PROPOSED BRIDGE REPAIR OF
CRANEHILL DRIVE OVER IVY CREEK

STRUCTURE #8010 – CRANEHILL DRIVE OVER IVY CREEK

PLANS REVISED	
SHEET NO.	DATE
1, 3, 4, 5, 6 9, 13, 14, 15 16, 17, 18, 19 20, 21, 22 23, 26	2/23/04 △1

△1 REV. 2/23/04

CRANEHILL DRIVE OVER IVY CREEK
SEQUENCE OF CONSTRUCTION

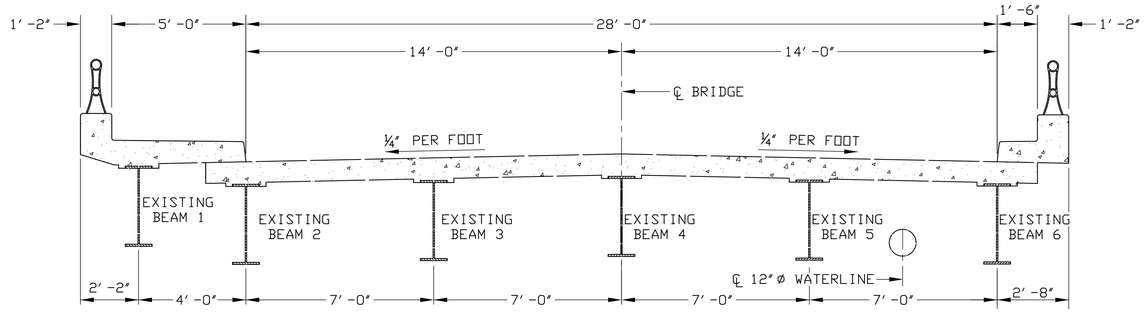
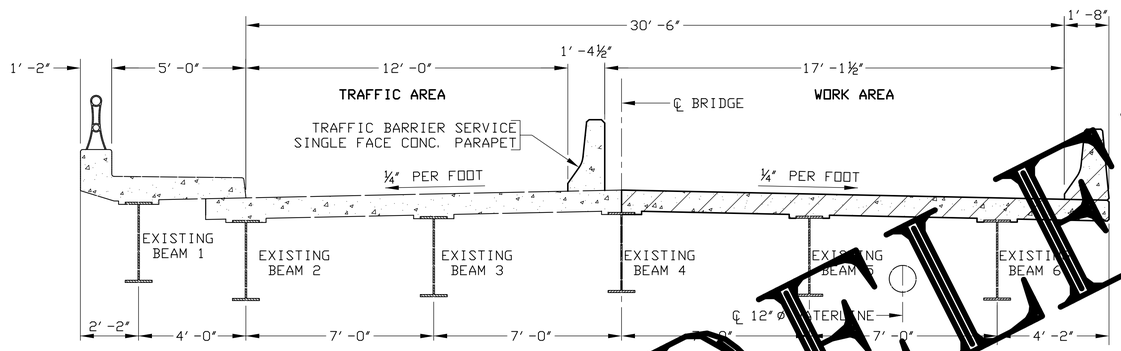
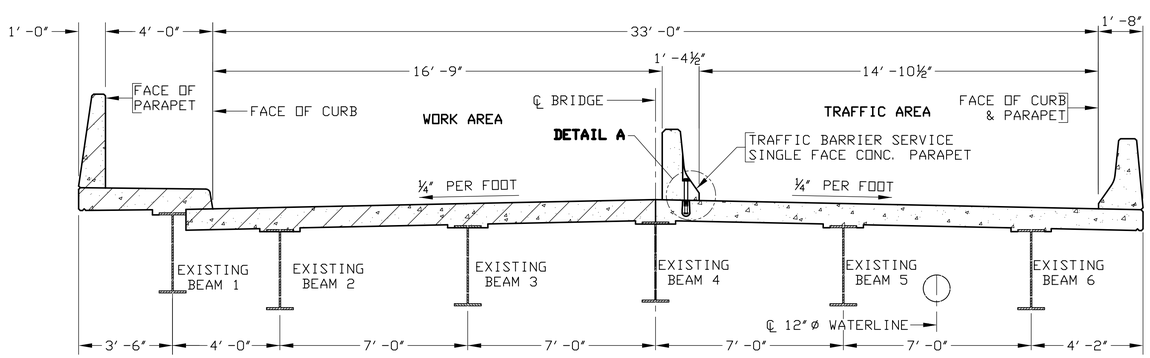
DELETED

THIS SHEET DELETED – FEBRUARY 23, 2004

1 TRANSVERSE SECTION – STAGE 1

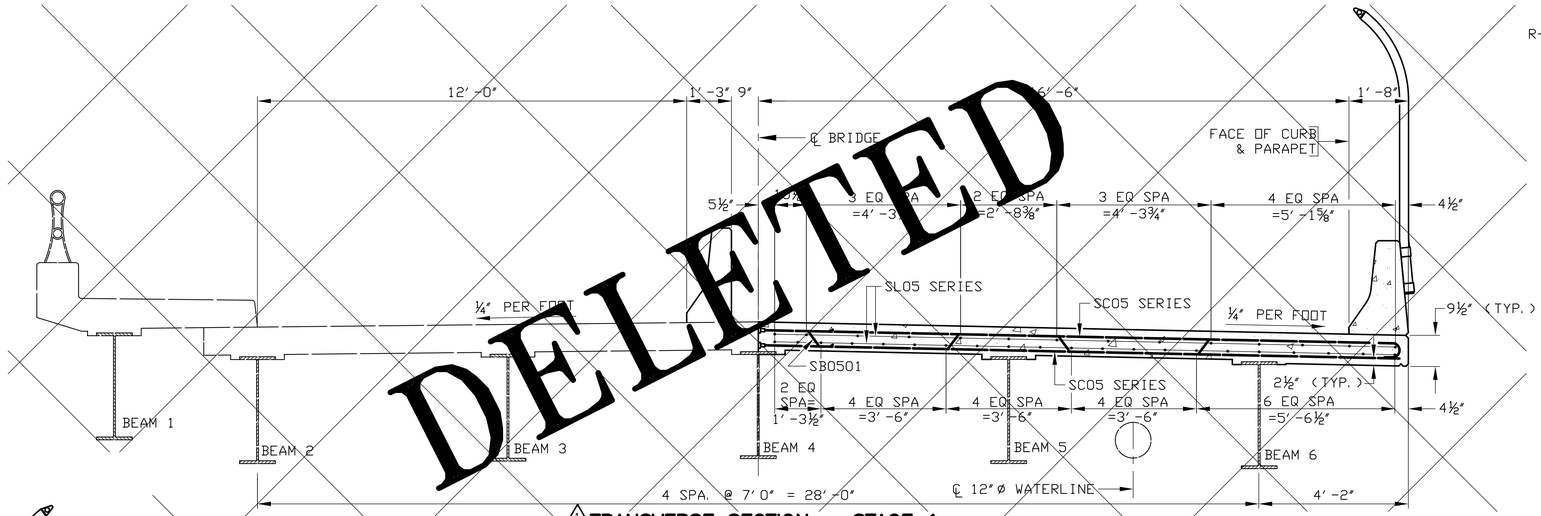
DELETED

1 DETAIL B

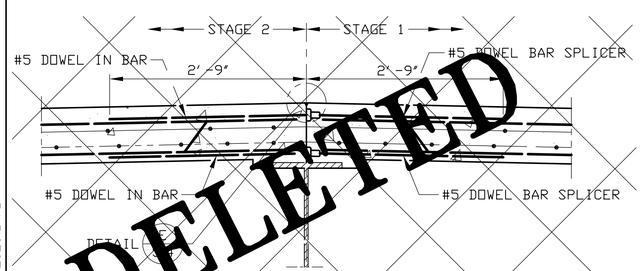
DELETED

WATERLINE SUPPORTS

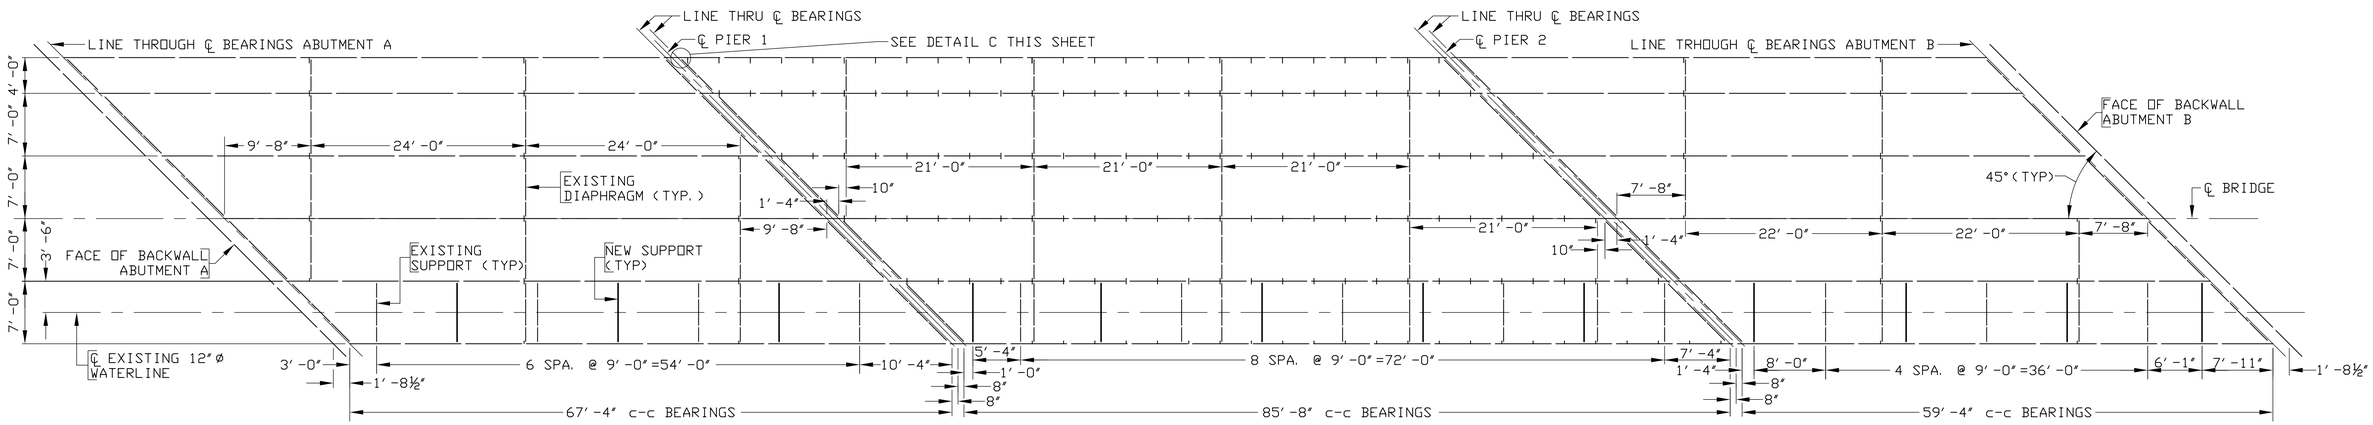
1 All new pipe supports (6x4½" angles) to be added between existing support angles shall be ASTM A709 Grade 36 and shall be added after all jacking of beams and substructure repairs have been made.

CRANEHILL DRIVE OVER IVY CREEK
PIER 1

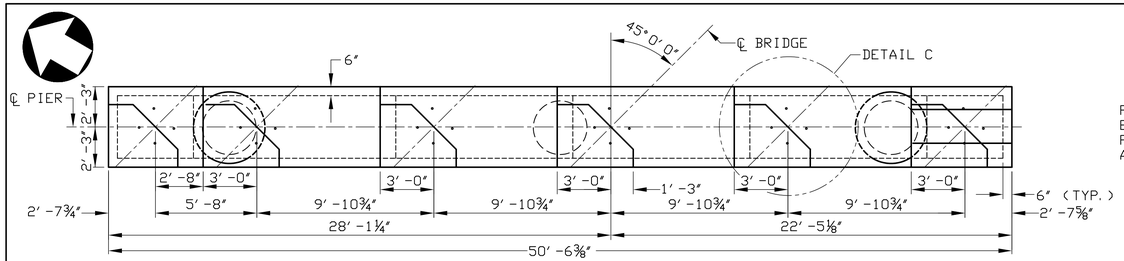
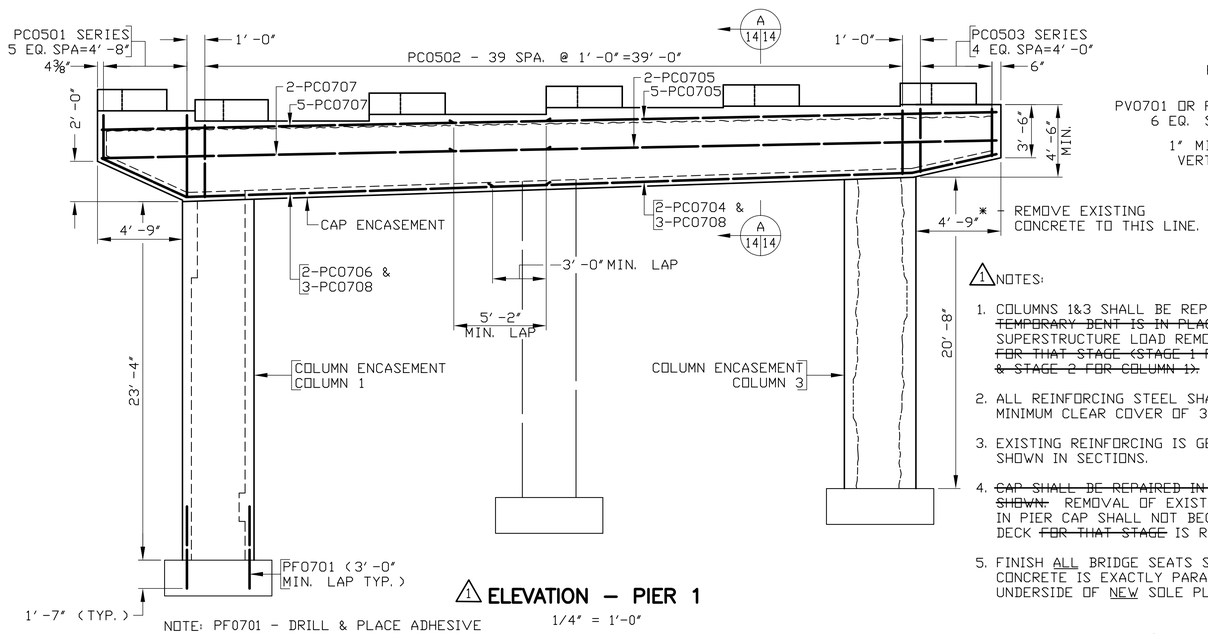
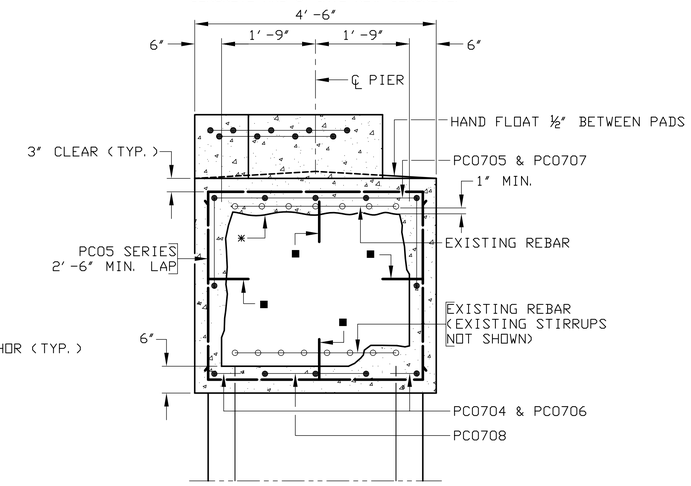
1. COLUMNS 1&3 SHALL BE REPAIRED WHILE ~~TEMPORARY BENT IS IN PLACE &~~ SUPERSTRUCTURE LOAD REMOVED FROM CAP ~~FOR THAT STAGE (STAGE 1 FOR COLUMN 3 & STAGE 2 FOR COLUMN 1).~~
2. ALL REINFORCING STEEL SHALL HAVE A MINIMUM CLEAR COVER OF 3".
3. EXISTING REINFORCING IS GENERALLY ONLY SHOWN IN SECTIONS.
4. ~~CAP SHALL BE REPAIRED IN 2 STAGES AS SHOWN.~~ REMOVAL OF EXISTING CONCRETE IN PIER CAP SHALL NOT BEGIN UNTIL THE DECK ~~FOR THAT STAGE~~ IS REMOVED.
5. FINISH ALL BRIDGE SEATS SO THAT CONCRETE IS EXACTLY PARALLEL TO UNDERSIDE OF NEW SOLE PLATES.

CRANEHILL DRIVE OVER IVY CREEK
PIER 2

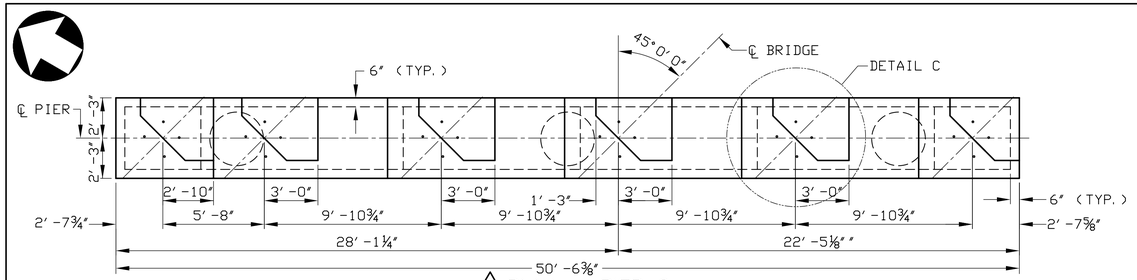
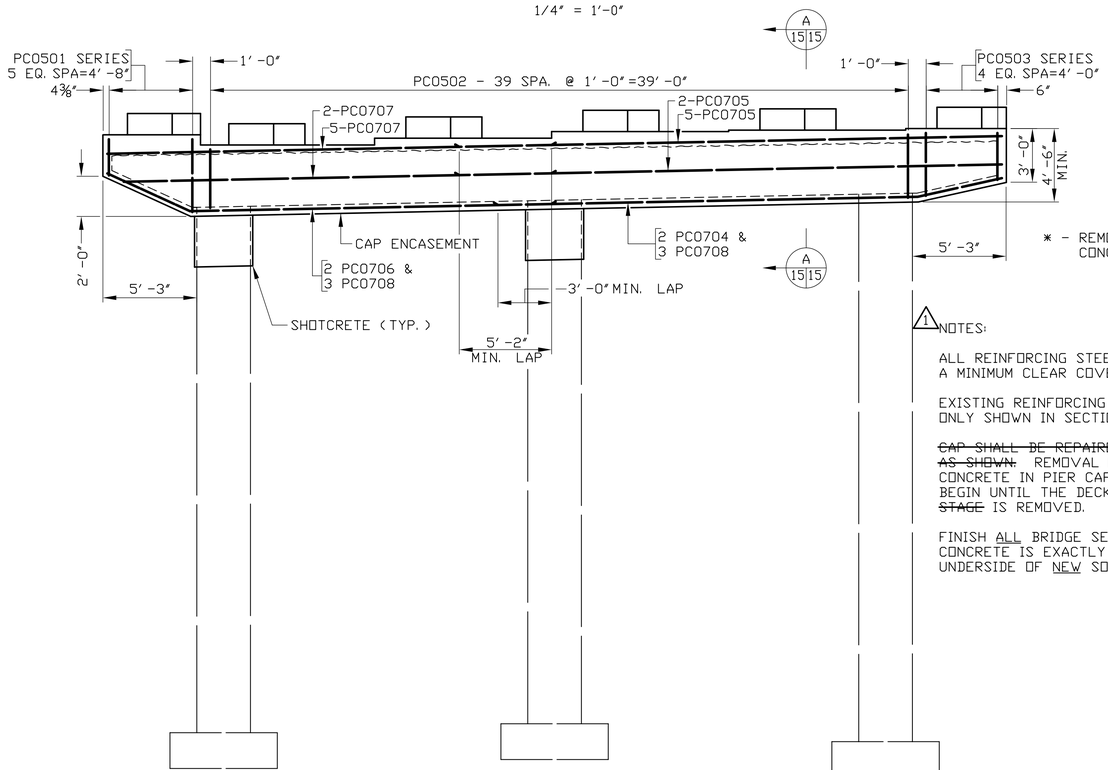
~~CAP SHALL BE REPAIRED IN 2 STAGES AS SHOWN.~~ REMOVAL OF EXISTING CONCRETE IN PIER CAP SHALL NOT BEGIN UNTIL THE DECK ~~FOR THAT STAGE~~ IS REMOVED.

CRANEHILL DRIVE OVER IVY CREEK
RIPRAP REPAIRS & SEQUENCE OF OPERATIONS

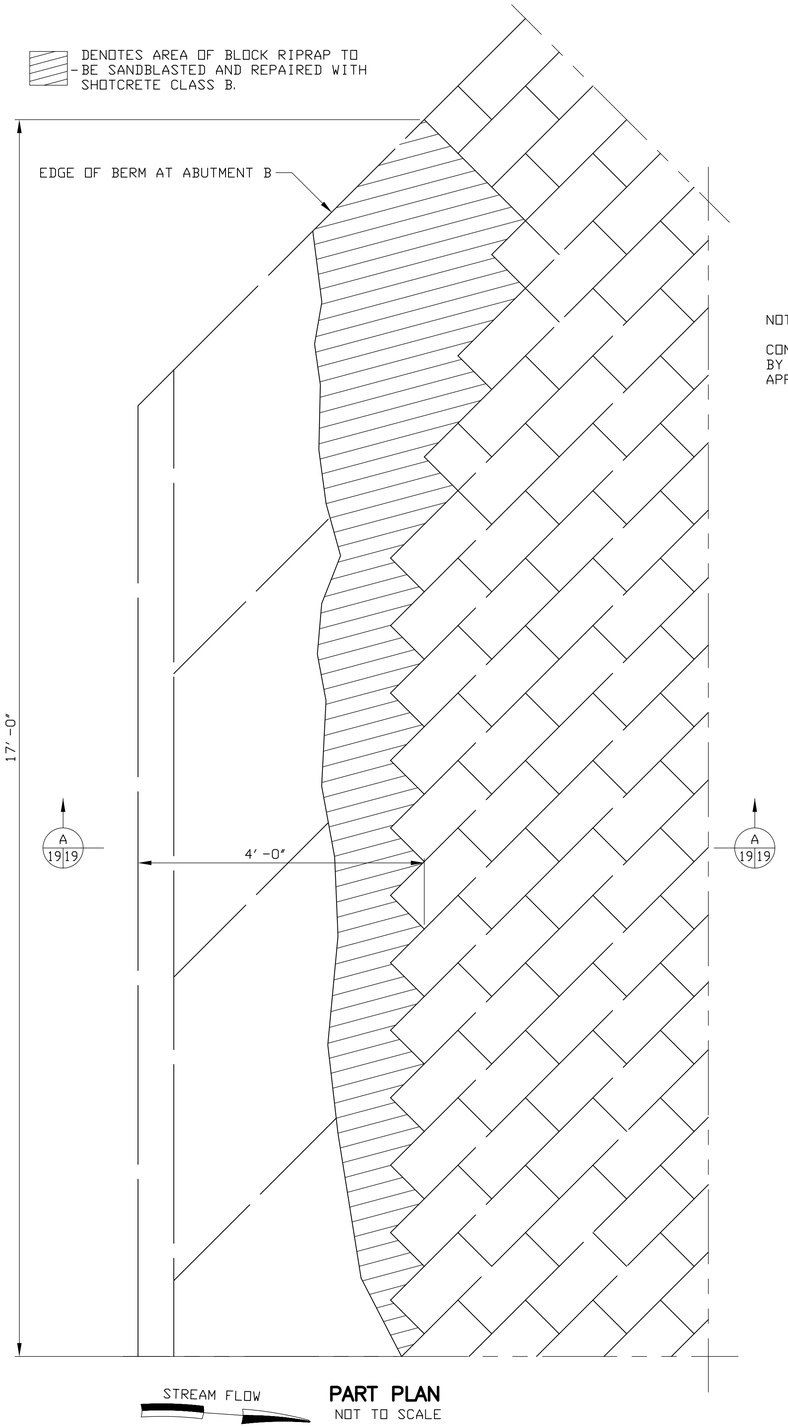
1 SEQUENCE OF OPERATIONS

1. ERECT ALL CONSTRUCTION SIGNS.
2. REMOVE DECK.
3. TEMPORARILY SUPPORT EXISTING WATERLINE, REMOVE U-BOLTS AND INSTALL NEW ROLLER SUPPORTS ON EXISTING ANGLES.

4. JACK AND BLOCK BEAMS (WITH BEAMS SUPPORTED FROM GROUND OR PIER FOOTINGS). CONTRACTOR SHALL LOOSEN WATERLINE HANGERS DURING JACKING OPERATION. HOWEVER, HANGERS SHALL BE KEPT SNUG AT ALL TIMES.

5. ENCASE PIER STEM AND ADD NEW STUB STIFFENERS IN SPAN B AND NEW SOLE PLATES TO ALL BEAMS.
6. SHOTCRETE STEMS NOT REQUIRING ENCASEMENT.
7. ENCASE PIER CAPS AND CAST ABUTMENT CONCRETE.

8. PLACE ELASTOMERIC BEARING PADS AND LOWER BEAMS ONTO NEW BEARING PADS.
9. CAST DECK, SIDEWALK AND PARAPETS.
10. SEAL EXPANSION JOINTS AT PIERS.
11. CLEAN AND PAINT STRUCTURAL STEEL.

12. COMPLETE BRIDGE DECK GROOVING.
13. COMPLETE WATERPROOFING CLASS III.
14. COMPLETE ALL OTHER ITEMS OF WORK ON BRIDGE.
15. COMPLETE ALL ROADWAY ITEMS.
16. REMOVE ALL TRAFFIC CONTROL AND OPEN BRIDGE FULLY.
